AGENDA
PLANNING AND ZONING COMMISSION MEETING
CITY OF CREVE COEUR, MISSOURI
MONDAY, AUGUST 3, 2020

2. Application #20-021: Site Development Plan for New Landscaping at 456 and 522 N. New Ballas Road

**APPLICATION TO PLANNING AND ZONING COMMISSION
#20-021 FOR SITE DEVELOPMENT PLAN FOR NEW LANDSCAPING AT
456 AND 522 N. NEW BALLAS ROAD**

SCOTT PROPERTIES
Landscape Development Plan for Medical Buildings @
456 & 522 North New Ballas Road

Figure 3: Proposed New Landscaping

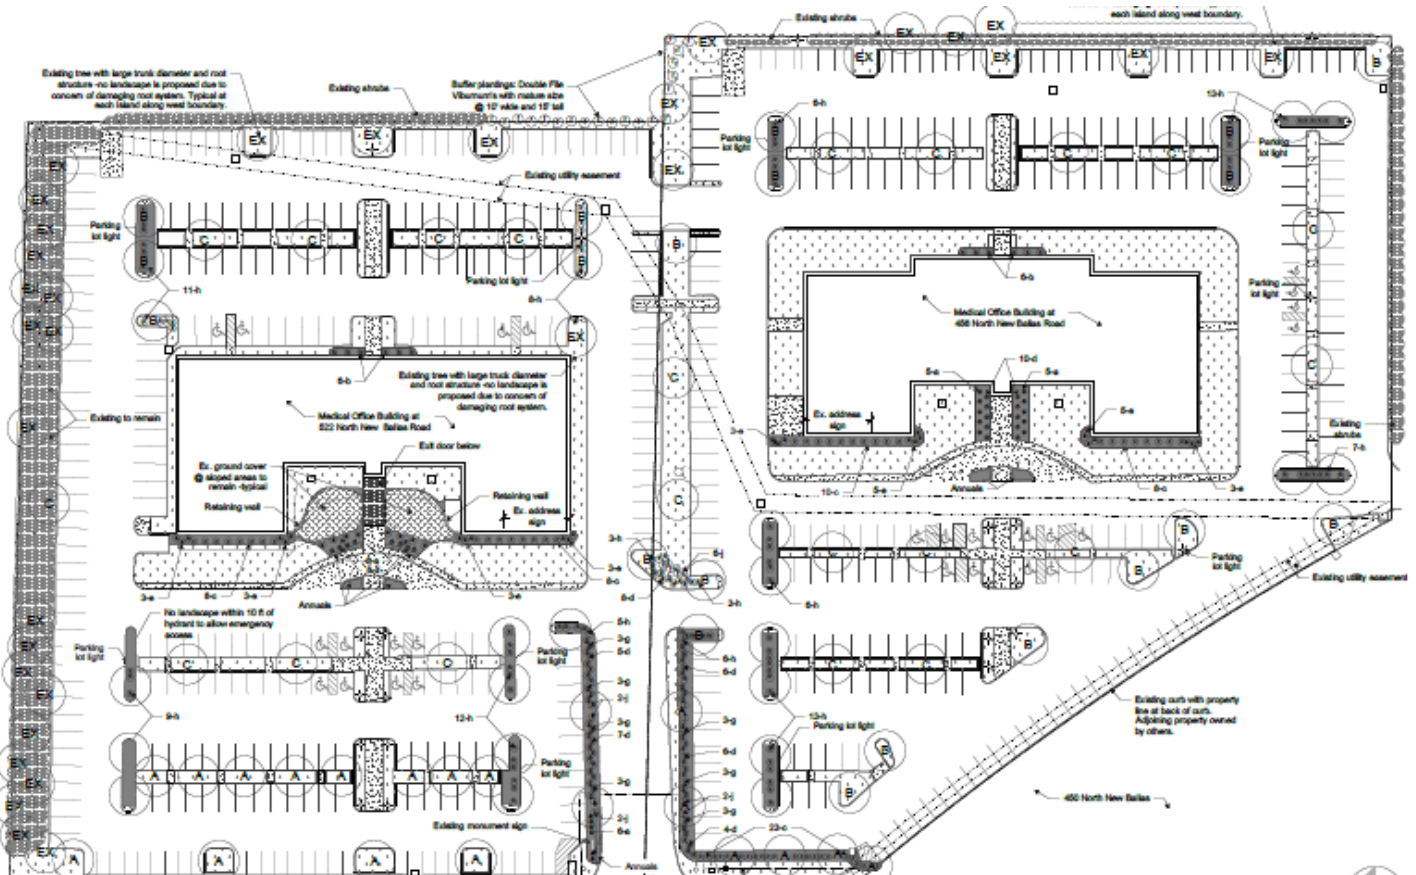
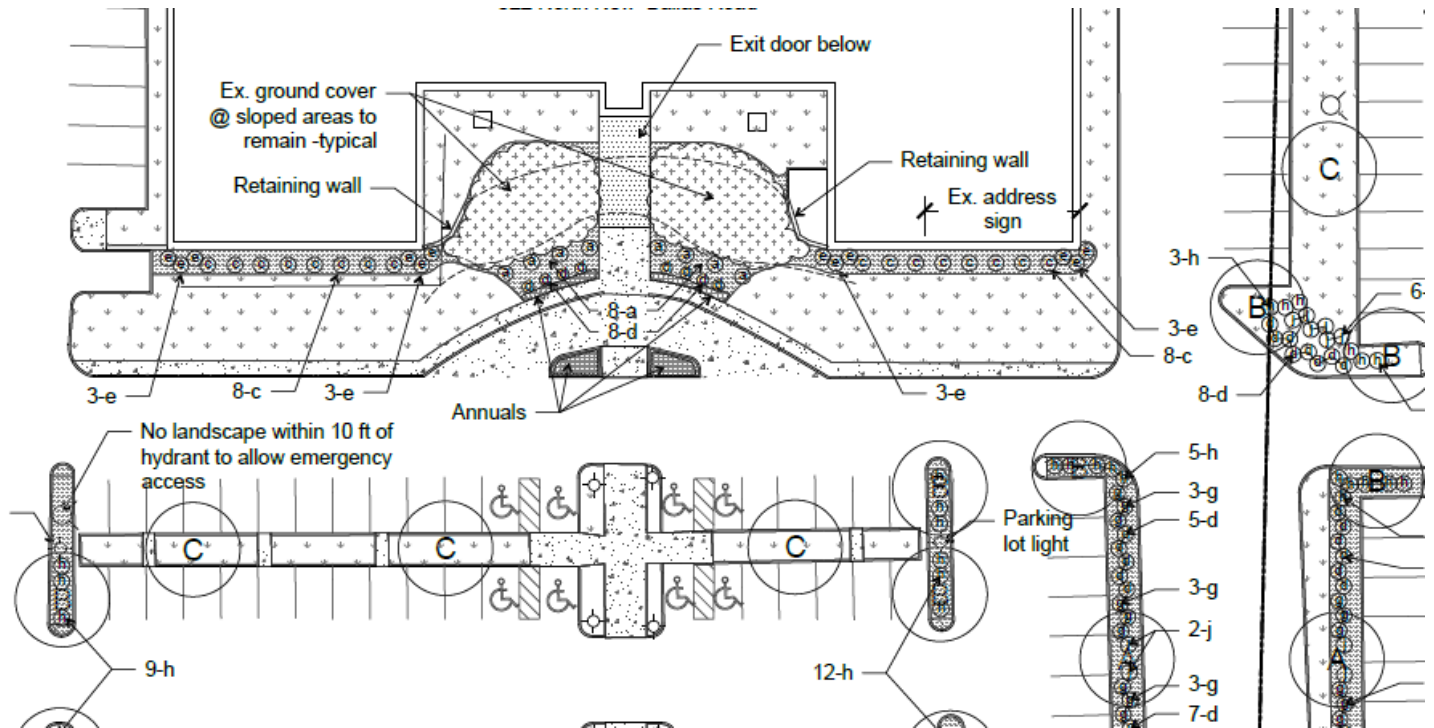
Staff's review of the proposed landscape plan shows that it lacks the same quality of design, and the amount and variety of plant materials as the prior approved plan. Additional plant material is needed to provide more variety of shrubs, with perennials and annuals, etc, throughout the site, and not just ground cover and trees within the parking lot islands, to meet with the recommendations of the Comprehensive Plan and Design Guidelines, as well as provide the level of design and plant materials that were removed. The prior landscape plan included a variety of shrubs and plant materials within the parking lot island, where the proposed is only showing grass or ground cover, in exchange for providing a greater number of parking lot trees. However, plant material along with walkways is missing. Therefore, Staff recommends that a condition that additional native plant material and variety should be provided to bring the proposed landscape plan closer to the prior approved plans.

The proposed landscape plan does not provide the same quality of design and quantity of materials as the prior approved plan. The Commission should discuss additional design options with the Applicant and provide direction to bring the site closer to compliance with the City's Comprehensive Plan and Design Guidelines, and satisfies the regulations contained in the Zoning Code.

- Additional large-scale and native shrubs should be provided around the building at the entrances to bring the site up to the standards of the previously existing landscaping and in consideration of the site coverage of over 70%.
- Additional plantings should be provided along the walkway within the parking lot to provide greater interest in similar manner as the prior landscaping, and to bring the site up to the level of the prior approved plan.
- If the honey locust is the species with thorns, it should be replaced with a Missouri Native tree as recommended by the City's Landscaping Guide.

2. The Landscape plan shall be revised to include greater number of plant materials and native varieties, eliminate the use of undesirable trees as identified by the City's Landscaping Guide, and provide large-scale plantings adjacent to the building, and along the parking lot walkway to bring the site closer to compliance with the City's Design Guidelines and Comprehensive Plan, as well as closer to the prior approved plan from 1991. The revised plan shall be subject to approval by the Zoning Administrator.

Figure 9: Close-up of the proposed plantings at 522 N. New Ballas Road

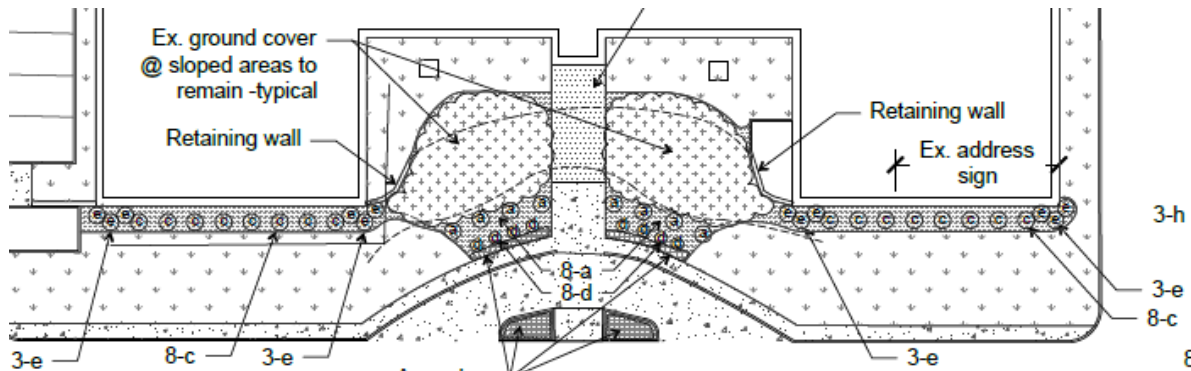
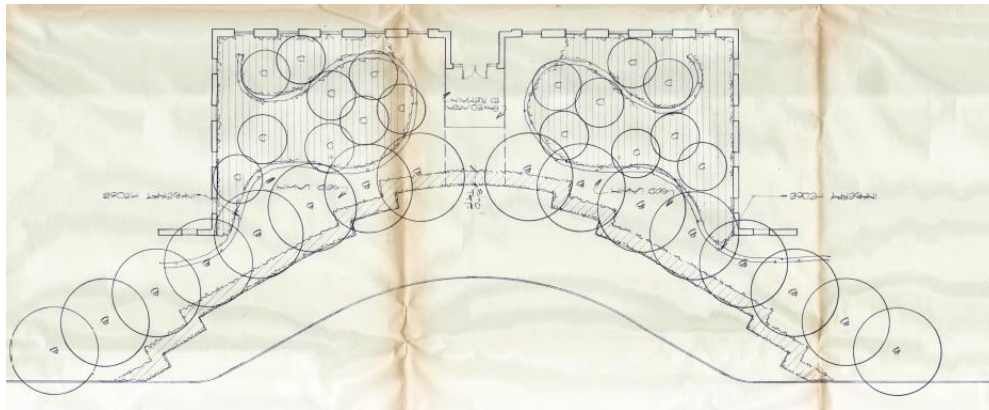
The large-scale landscaping that was at the front of the buildings of the 1991 plan are not provided with the same quality and scale in the proposed plan, with only base shrubs at the building. Therefore, Staff recommends that additional trees and larger scale plantings are needed to soften the building and to meet with the recommendations of the Design Guidelines.

Figure 9: Close-up of the Landscape plan for the new addition and the billboard with highlighted areas for additional landscaping.

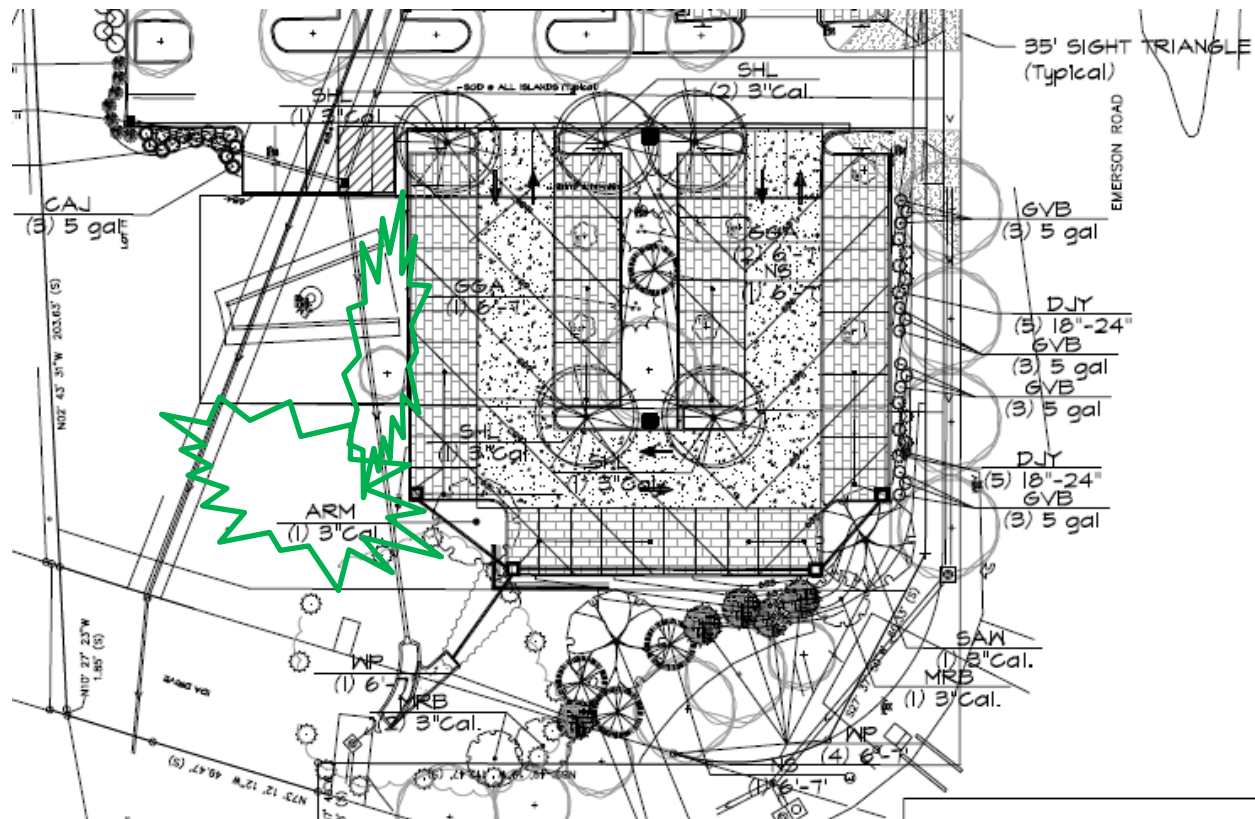
Staff has included that landscaping along the west parking rows should also be provided for headlight screening.

Figure 11: Close-up of the Applicant's Photometric Plan showing that lighting levels to be less than 1 fc at the property line.

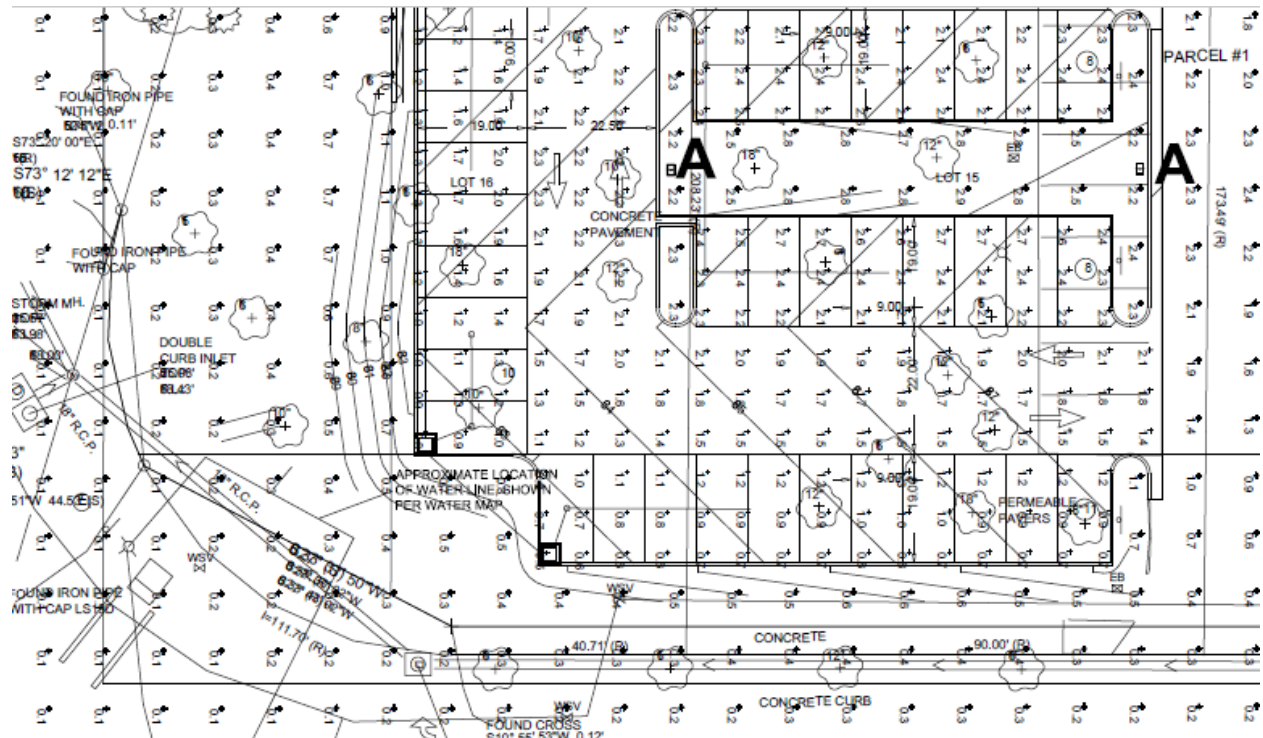
The new parking area is proposed to have new lighting that meets with these regulations. However, the site photometric plan indicates that the existing parking lots are flood lights. Therefore, a condition of approval includes that all lighting shall be downcast and fully shielded, and that the existing flood lights shall be replaced with the same light fixtures as the proposed new fixtures. If additional light fixtures are needed, Staff has included a condition that Staff shall have the authority to approve additional light fixtures to meet with the requirements above.
